Re: 4th Avenue 5-Plex – Trip Generation Analysis and Scoping Memo

SUBJECT: Canby NW 4th Avenue 5-Plex
Transportation Analysis Findings and Conditions

SUBJECT: Canby NW 4th Avenue 5-Plex
Transportation Analysis Support

FIGURE 1: SITE PLAN

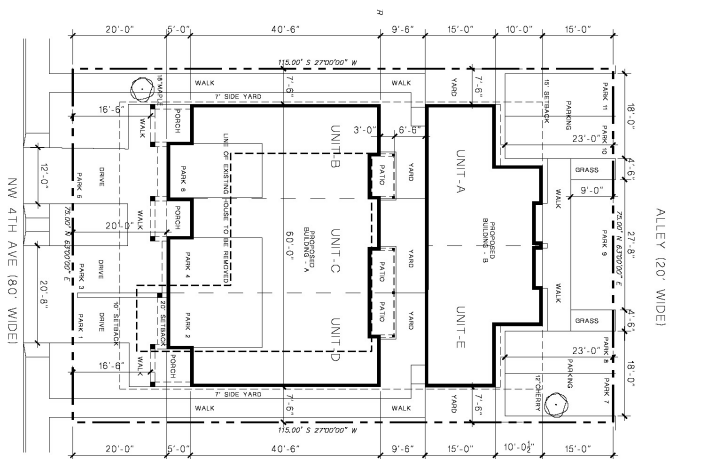
The proposed project is located on the northwest side of NW 4th Avenue between N Elm Street and N Fir Street in Canby, Oregon. The proposed development is for 5 attached residences in two separate buildings. The site plan can be seen in Figure 1.

Access to the site is proposed via two driveways to the 3 residences fronting NW 4th Avenue (the proposed driveways to Units C and D were considered a single shared driveway); two driveways will also be provided for the 2 residences in the back off the alley.

The proposed site plan (shown earlier in Figure 1) shows two driveways to the 3 residences fronting NW 4th Avenue and two driveways for the 2 residences in the back off the alley. These driveways will provide off-street parking for each residence and will provide adequate circulation to the surrounding existing roadway network.

The site plan also includes a proposed sidewalk from NW 4th Avenue connecting to the entrances of Units B, C and D, and to the entrances of Units A and E fronting the back alley.

The proposed driveways on NW 4th Avenue will be approximately 15 feet from side property lines and 10 feet from each other⁴, complying with the spacing standard.

1. The development shall pay Transportation System Development Charges to address citywide impacts.
2. The development shall design and reconstruct the existing 5-foot sidewalk along the NW 4th Avenue frontage with a 6-foot sidewalk.
3. Minimum sight distance requirements shall be met at all site accesses. Sight distances should be verified in the final engineering/construction stages of development.
